CEREC SW 5.2.3

Update Description (EN)

Changes made to previous version 5.2.2:

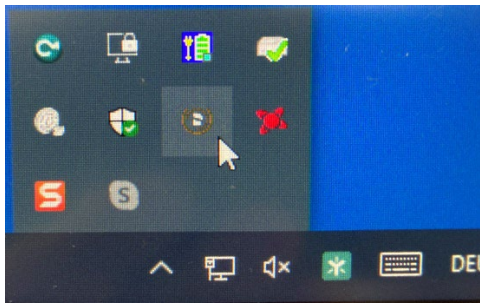
CEREC Zirconia+ Multi-job option for CEREC SpeedFire

Adjusted wall thicknesses for CEREC Zirconia+ and CEREC MTL Zirconia for quality assurance in Super Fast mode
